FACILITY: Waterford Steam Electric Station, Unit 3

SUBJECT: SUMMARY OF MARCH 19, 2020, CATEGORY 1 PUBLIC MEETING WITH ENTERGY OPERATIONS, INC. REGARDING A PLANNED LICENSE AMENDMENT REQUEST TO INSTALL DIGITAL SYSTEMS IN ACCORDANCE WITH DIGITAL INSTRUMENTATION AND CONTROL INTERIM STAFF GUIDANCE (DI&C ISG)-06 REVISION 2, "LICENSING PROCESSES" (EPID L-2020-LRM-0016)

DRAFT TECHNICAL SPECIFICATIONS MARKUP

Waterford 3 CPC Upgrade
Tech Specs - Markup Description

Figure 3.1 - 1A

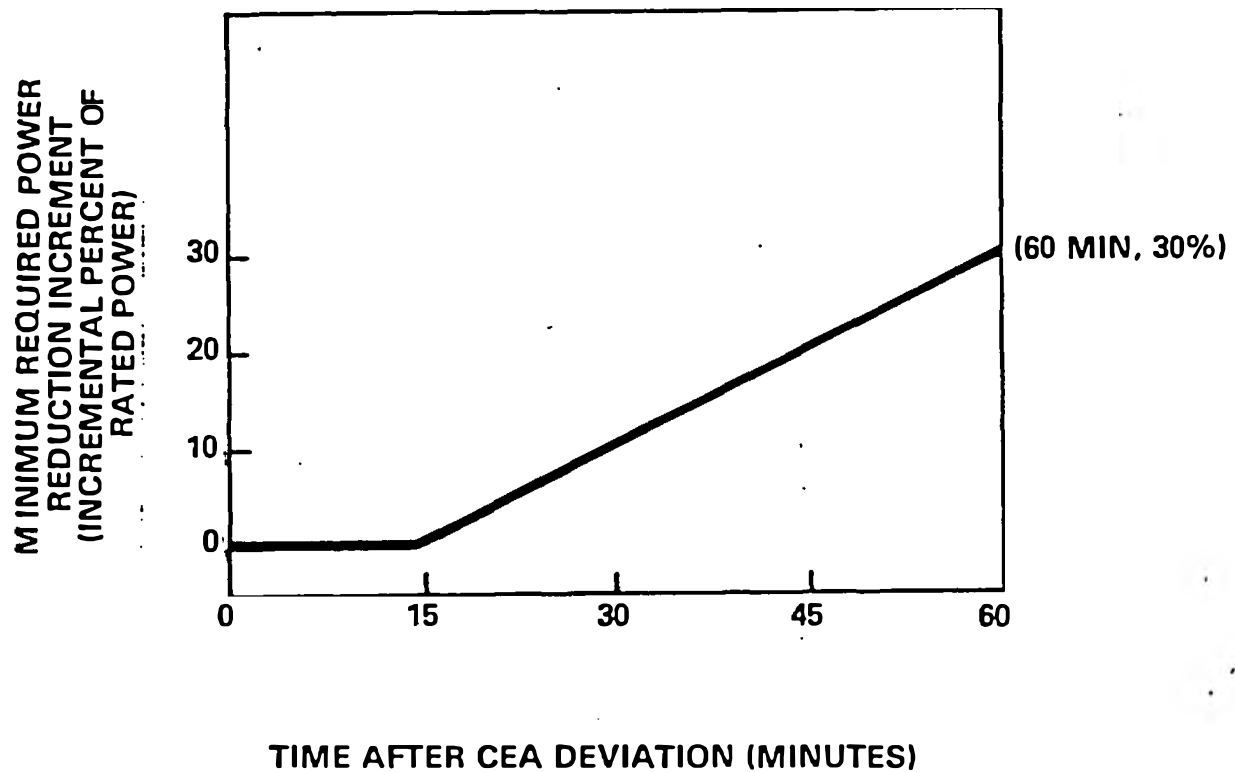
3.1.3.1	CEA Position	SR 4.1.3.1.1 CEA Position Verification - Revised wording to align with 8 CEAC configuration (For instance, "Both" changed to "All" for when no CEACs Operable)

all

on any OPERABLE CEAC.
